MEETING OF THE MINTURN PLANNING COMMISSION Minturn, CO 81645 • (970) 827-5645

Wednesday, May 12, 2021

Re: 701 Boulder Street – Bilello New Residence Modification to Approved Plans

Re: 482 Eagle River Street – Hutton New Residence Modification to Approved Plans

SITE & LANDSCAPE

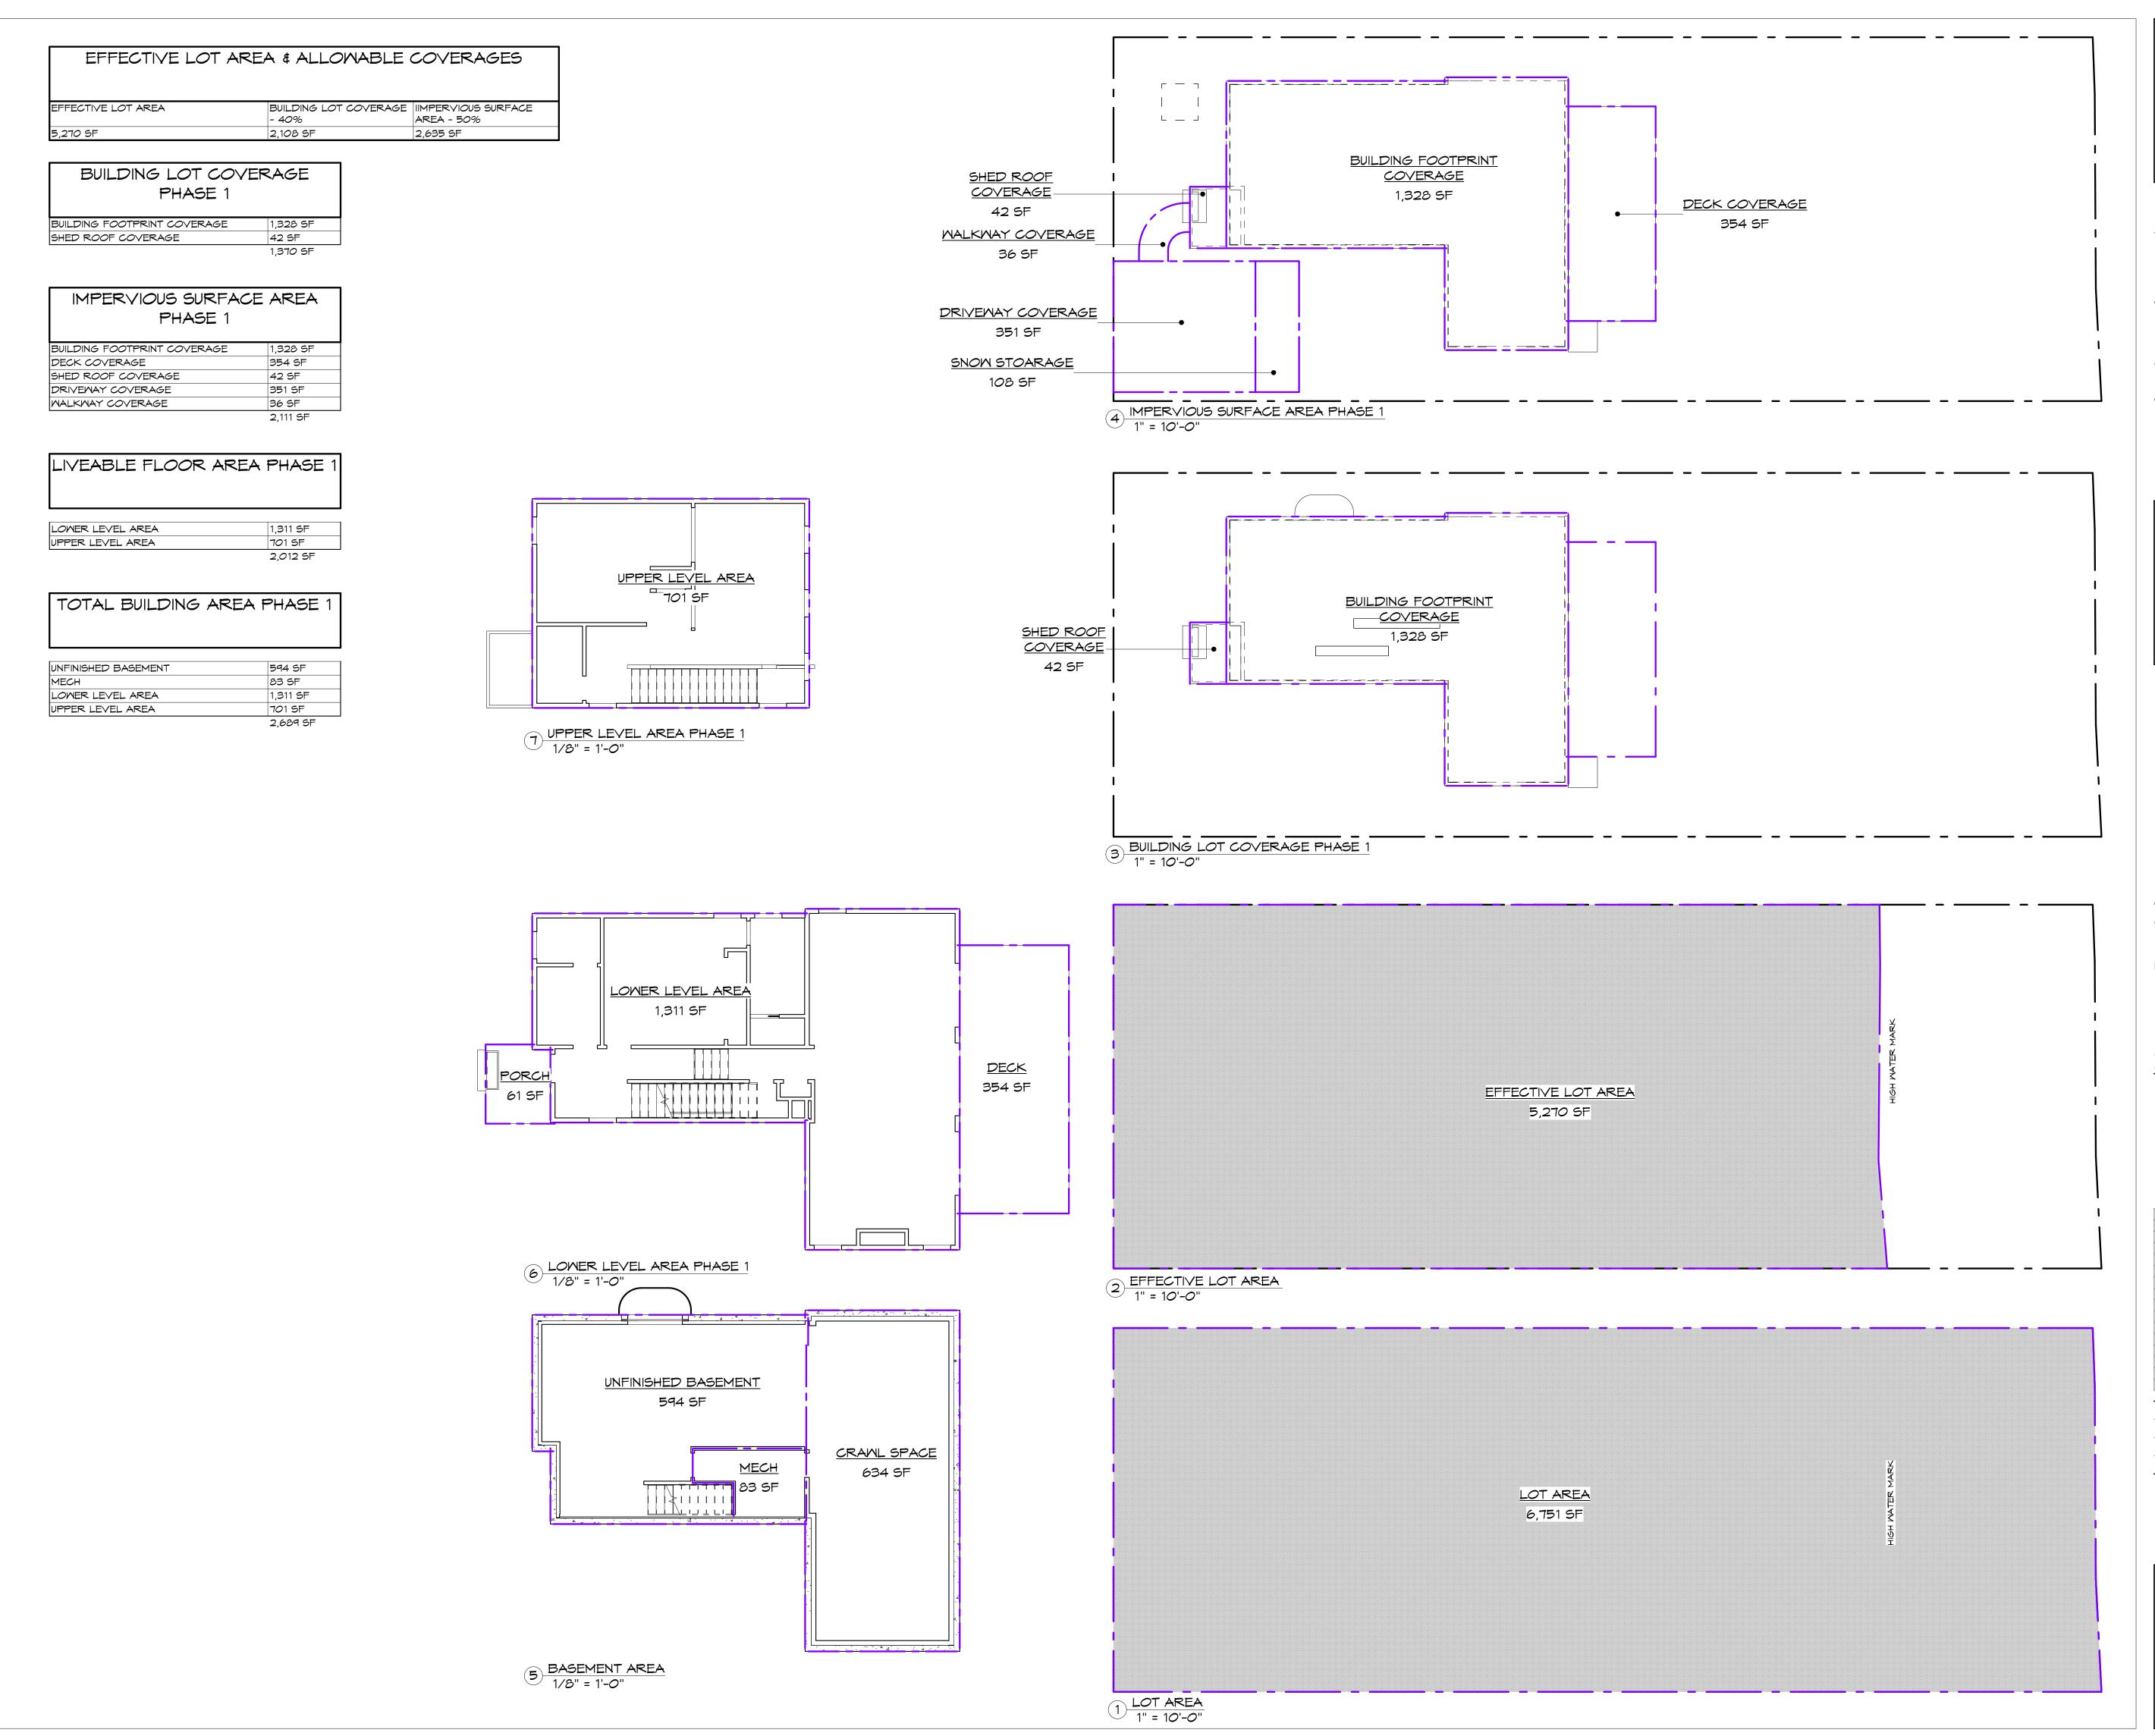
- The trees between this property, Lot 14, and Lot 15 to the north have been removed. (Sheet AS1)
 - It was our initial intention to keep the trees as much as possible, as was indicated
 on the design review application drawings. However, as we started to discuss
 actual construction practices, it became clear the trees were too close to the
 foundation to survive excavation of the foundation.

- 6' wood fences have been added to the north and south property lines (Sheets 01, 02, AS1)
 - The existing wood fence on Lot 13 to the south currently encroaches on this lot.
 Steve Hutton and the owner of Lot 13 have a verbal agreement that the existing fence will be taken down, and a new fence will be constructed during construction of the new house.
